RCA-56-22-008-1: Replace Exterior Door Handle Levers

Document Type	Customer Satisfaction Campaign Bulletin
Date	December 19, 2022
Affected Region(s)	USA
Affected Model(s)	R1T
Model Year(s)	2022
Approximate Build Dates	August 2021 - January 2022
 Refer to the FSA Dashboard to determine if this document applies to a specific vehicle.	
Vehicle System	56 - Closures
Minimum Service Location	Mobile

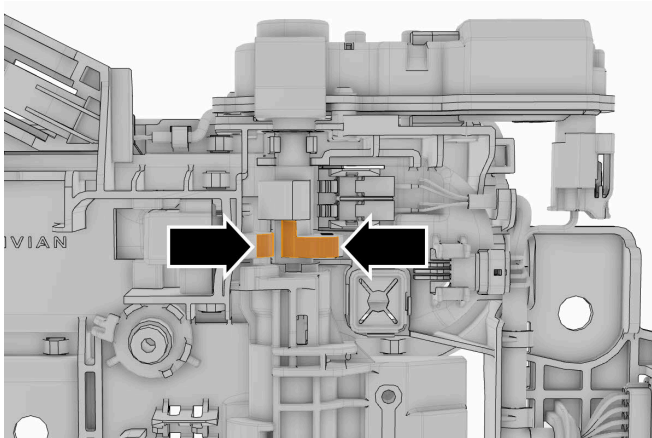
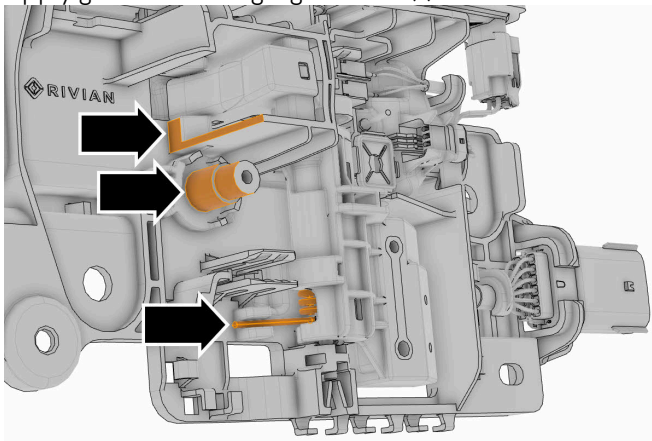
Rivian is initiating a customer satisfaction campaign for some model year 2022 R1T vehicles that may have been built with door latch mechanisms that are prone to water intrusion. In rare instances the handle lever inside the door may bind, preventing a door from latching or unlatching. If the door does not latch, the customer would notice it swinging freely and a “door ajar” indicator light will illuminate on the driver display. If the door does not unlatch, the customer could exit the vehicle through another door. Rivian will replace all 4 exterior door handle levers with upgraded components. Rivian is launching this campaign for customer satisfaction and to ensure the quality of Rivian vehicles.

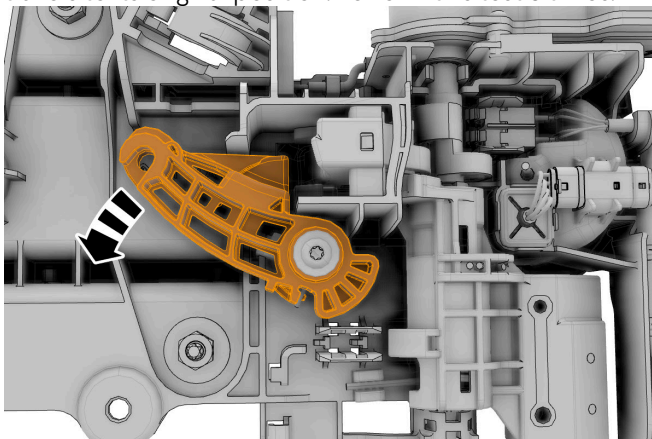
1. In 4 locations: Remove: Lever, Exterior Door Handle.
 - Front: refer to service manual procedure 565070010.
 - Rear: refer to service manual procedure 565071010.
2. Apply grease to the highlighted area(s).

3. Replace the component(s).
 - Front: refer to service manual procedure 565070010.
 - Rear: refer to service manual procedure 565071010.
4. Before reinstalling the assembly to the vehicle, pull the lever as shown. Make sure that the lever fully travels to its original position. Perform this test 3 times.
